408.4

Sediment Traps

CHANGE TYPE: Modification

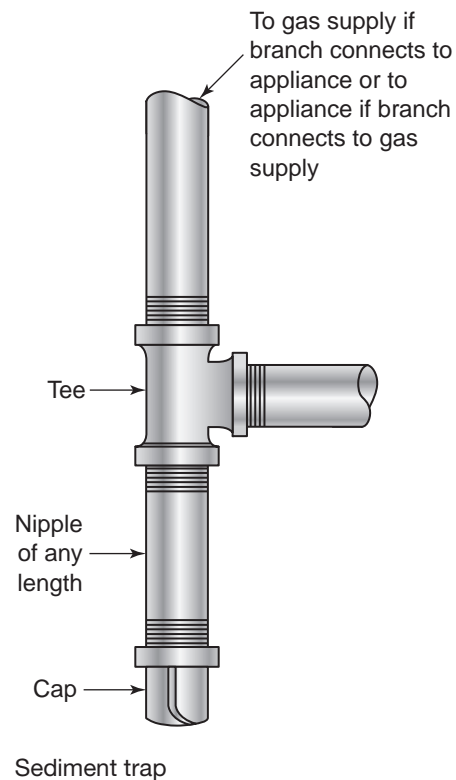
CHANGE SUMMARY: An illustration of a sediment trap is now included within the IFGC in order to clarify the intent of the provisions.

CHANGE SIGNIFICANCE: Because of misunderstandings as to how a sediment trap is to be constructed, an illustration has been added to the code text to clarify the intended installation method. In addition, decorative vented gas appliances and gas fireplaces are no longer required to be installed with a sediment trap. Although these appliances are susceptible to harm from debris, they are also manually operated; therefore, the user would be in attendance and aware of any problem.

2012 CODE: 408.4 Sediment Trap. Where a sediment trap is not incorporated as part of the appliance, a sediment trap shall be installed downstream of the appliance shutoff valve as close to the inlet of the appliance as practical. The sediment trap shall be either a tee fitting having a capped nipple of any length installed vertically in the bottommost opening of the tee as illustrated in Figure 408.4 or other device approved as an effective sediment trap. Illuminating appliances, ranges, clothes dryers, decorative vented appliances for installation in vented fireplaces, gas fireplaces and outdoor grills need not be so equipped.
